Subject: Fwd: Written Objection to DA 2021/1164 - 521 Barrenjoey Road, Bilgola Beach, NSW 2107

Written Objection to DA 2021/1164 521 Barrenjoey Road, Bilgola Beach, NSW 2107

The proposed development ("**DA**") as I understand, seeks approval for the Construction of a Dwelling House including a swimming pool requiring: construction of Site Access; Clearing and Removal of 28 Trees; construction of new entrance works in the road reserve; significant site preparation works; excavation to depths of approx. 20 metres; tunnel excavation for a length of approximately 20 metres into rock, at a depth of up to 20 metres ; installation of a car turntable; installation of two internal lifts (height of 14 and 20 metres), construction of a tiered dwelling comprising 7 separate levels over the entire site; cladding; façade treatment; and landscaping works.

Figure 1 - Section showing proposed tree (in green) located above all other features on the section plan

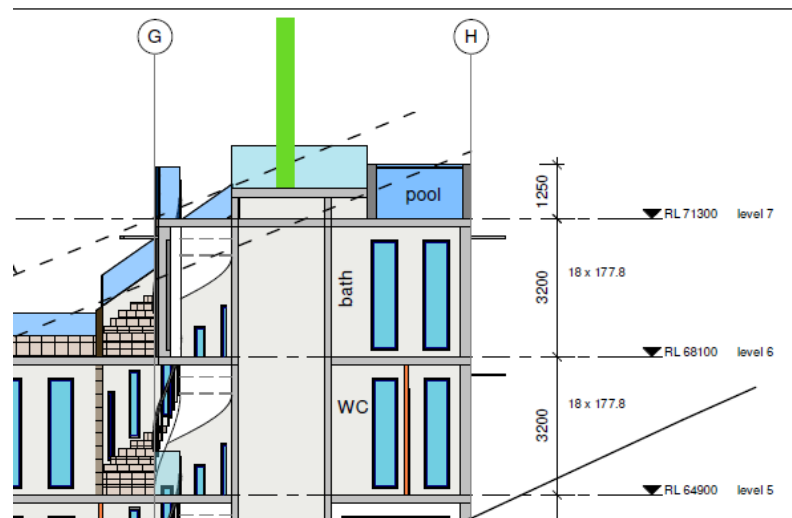
An example of this is the proposed *Plumeria rubra* (frangipani) tree proposed to be planted at pool deck level in the landscape plans – which is proposed to grow to a height of 4m (refer landscape plan).

The sections of the development have failed to note, or show this. The sketch below shows the scale of the proposed tree.

Based on the limited information provided, it is difficult to understand how this would impact the view at our property – however, based on the misleading sections – and failure to provide elevations as required in the landscape plan, it would appear that the proposals approach to maximising views, at the expense of others has been the only consideration in preparation of the proposal. Particularly when a 4m tree is proposed to be planted some 31 metres above the foundation of the actual structure.

Figure 3 - Excerpt from Development Plans with overlay of SP2 Zones shown in yellow

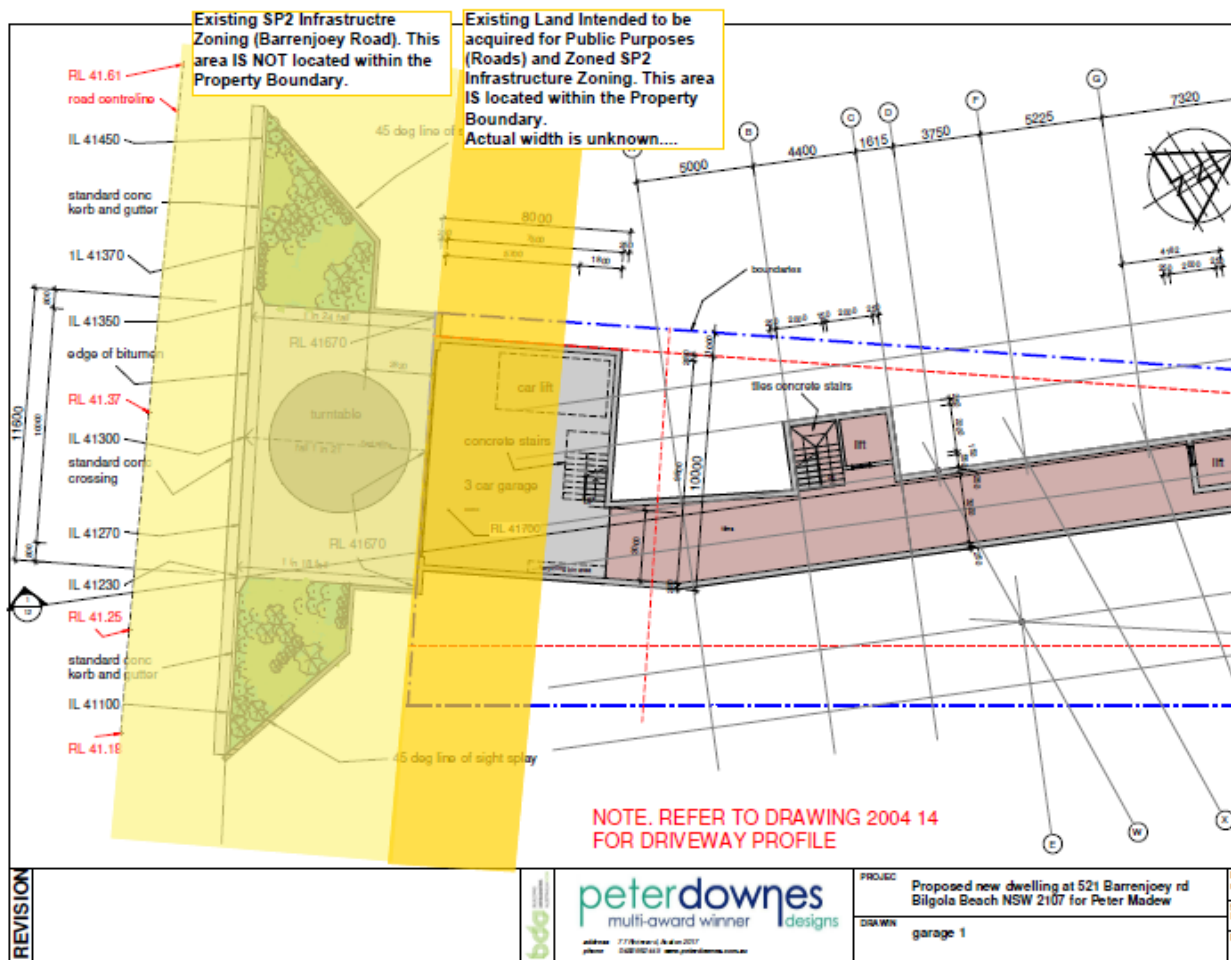
- There is no identification of the SP2 zoned area shown on the survey plan where it sits within the site boundary – it is questioned whether the proponent is aware of this?

- There is no identification of the SP2 zoned area on the proposed development plans (where it sits within the site boundary) which may have an impact on future road works.

- The proposed development specifically contravenes point 3 which states “*Development consent must not be granted to any development on land to which this clause applies other than development for a purpose specified opposite that land in Column 2 of that table.*” Where the purpose in column 2 is identified as “roads”. Whilst no dimensions are shown, and therefore an accurate assessment is unable to be undertaken, it would appear that there are built form items within the location of SP2 zoned area both inside and outside the site boundary. Both of these should be identified in further detail. It is therefore entirely incorrect for the proponent to consider that any or all of the proposed building elements in this area shown on the plans (including driveway, handrails, retaining walls, gardens, plants, shrubs, turntable, store, garage, walls, skylights etc) could be in any way defined as “roads”.

- A simple search of the Northern Beaches website (figure 2) provides the map which would appear to clash with the proposed building works.
- Whilst Schedule 1, Clause 24 of the LEP does permit development on land intended to be acquired for public purposes it DOES NOT permit development on Land Zoned SP2 Infrastructure which is zoned “*To provide for infrastructure and related uses*” – refer to key point number 2 for further information. In consideration of development on land intended to be acquired for public purposes, the consent authority must consider:

Figure 4 - Borehole location with proximity to major excavation locations, and surrounding properties

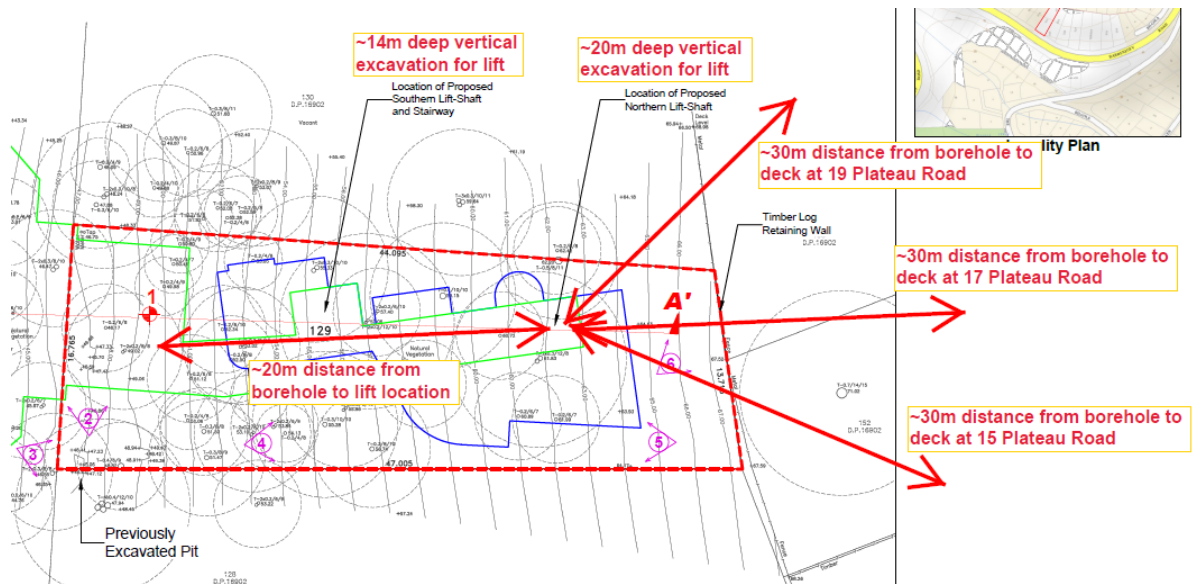
The plans and proposal suggests very significant excavation (20m deep and 14m vertical excavation for the lifts, as well as a horizontal tunnel up to 20 metres deep). We feel there should be significantly more work undertaken in the planning phases rather than simple assumptions made from one borehole drilled in a location which is not in the main excavation area, particularly where high-risk tunnelling and vertical excavation is proposed.

We believe it would be reckless for both council and the builder / developer to consider any form of excavation including vertical shafts and tunnels in such an unknown, and high risk environment where surrounding properties are close by without further investigation, studies, as well as any ongoing compliance and monitoring.

We attach two figures below to assist in demonstrating our concerns.

Figure 6 - Excerpt from Geotechnical Hazard Map - Sheet GTH_016 – Subject Property shown with blue “X”

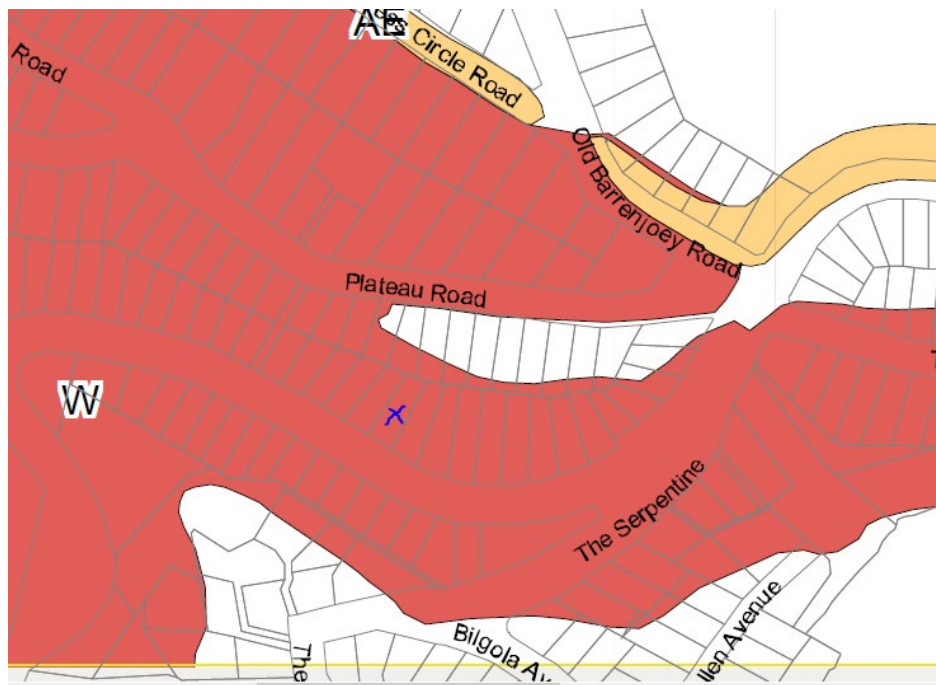
Comment: It is surprising to note that the proponent has failed to identify, and address that the site is located in an area identified as “Geotechnical Hazard H1” on Geotechnical Hazard Map - Sheet GTH_016.

Furthermore, it would appear that there has been no assessment of any requirements to address this clause within the proposal, statement of environmental effects, and/or the geotechnical report. This is extremely concerning and demonstrates a lack of understanding of the proposal in the environment.

The proposal therefore cannot be approved as it does not address fundamental and simple requirement of the LEP.

Figure 7 - Dial before you Dig Enquiry - Sydney Water nearby Assets

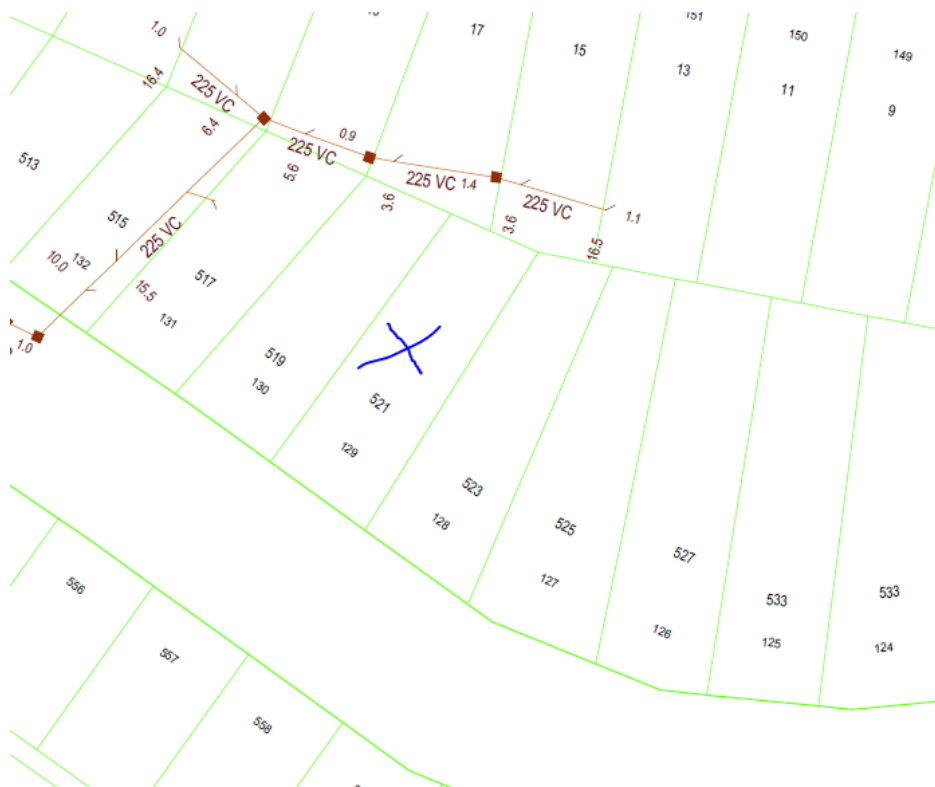
Comment: It is unclear as to how the proponent has considered how the proposal can be serviced for three essential services – water, sewer and power.

- In the event that sewer connection is available at 515 Barrenjoey Road, the Consent Authority should also consider how any connection to the point is made due to the fact that Barrenjoey Road is extremely narrow – and busy, as well as contains area reserved for future infrastructure upgrades. This should be investigated, and provided by the proponent for further consideration prior to any development consent being granted.

Figure 9 - Carpark width versus lot width

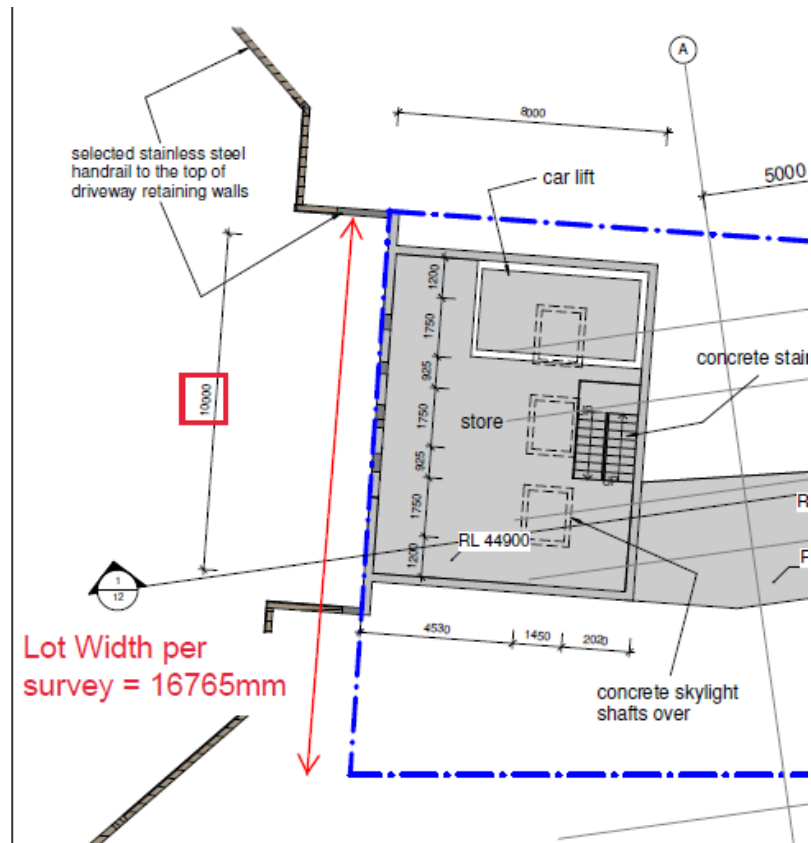
The width is therefore 59.64% of the lot frontage and is non-compliant. The sketch from the DA plans below provides further details.

The Consent Authority should refuse the development on the basis of this non-compliance.

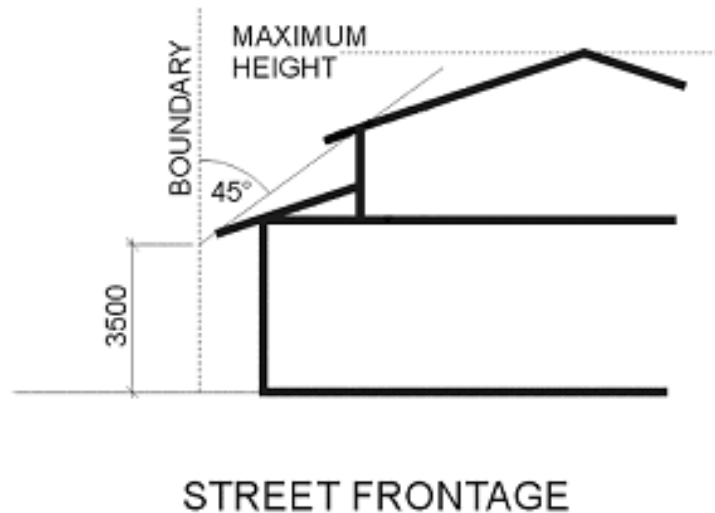
Comment: The proposal appears to comply with some setbacks however a portion of the dwelling (side and rear) appear to encroach on the setback and is therefore non-compliant in at least two different locations for a portion of the development.

As a minimum, the plans should be updated to show compliance, and non-compliance with dimensions to allow full assessment.

It is unclear why a non-compliance is deemed acceptable by the Proponent with no apparent justification or reasoning, or effort to make the proposal compliant.

The proposal should be rejected by the Consent Authority based on non-compliance of all (front, rear, side) setbacks.

Figure 11 - SP2 Zoning on the site - required to be removed from area calculation for landscaping assessment

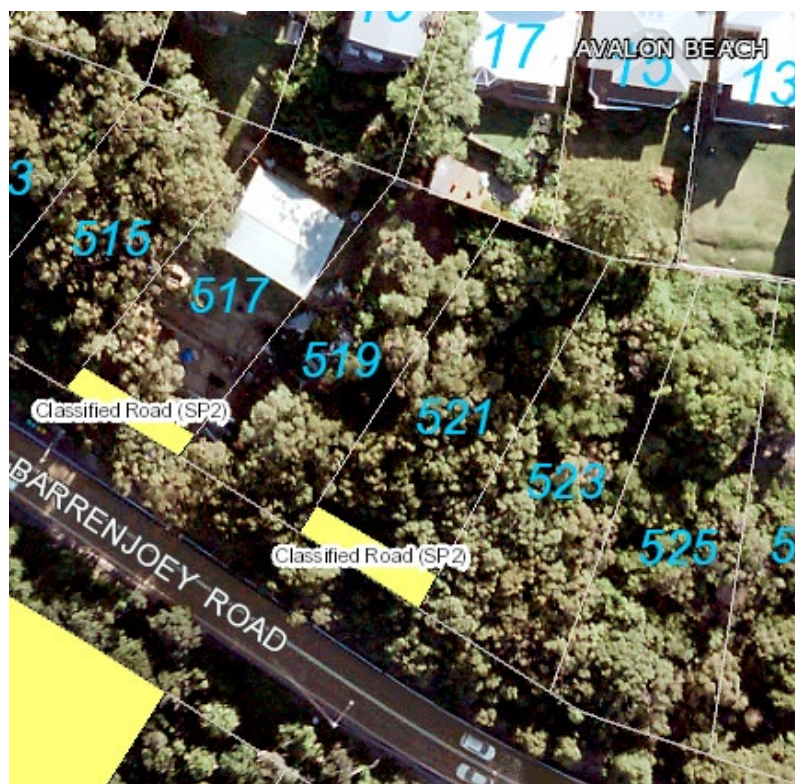
Comment: The proposal does not comply with the Development Control as the area Zone SP2 has in fact been included in the total site area. The area which is Zoned SP2 (at the Barrenjoey Road side) should be removed and the calculation updated.

Furthermore, some of the landscaped area forms part of non-compliant building areas at the side and rear setbacks which should be removed to ensure compliance – as a minimum.

The sketch below shows the area zoned SP2. Inclusion of this area is a breach of the Development Control and the proposal should be refused by the Consent Authority until this is rectified.
